The authors thank the reviewers for a very detailed reading of the paper and substantive comments that have clearly improved the research and its presentation. Below are the original comments in blue color and italics and our responses below them.

Anonymous Referee #1

Summary

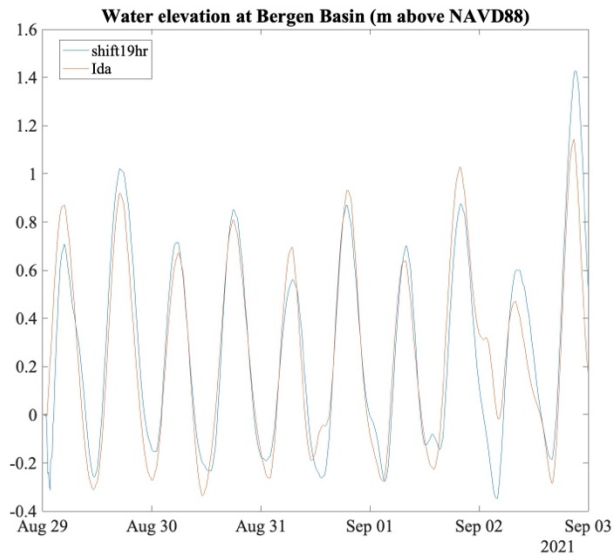
32. *Figure 7: combine with Figures 4-5.*

Change made. Figure combined to Fig. 3c.
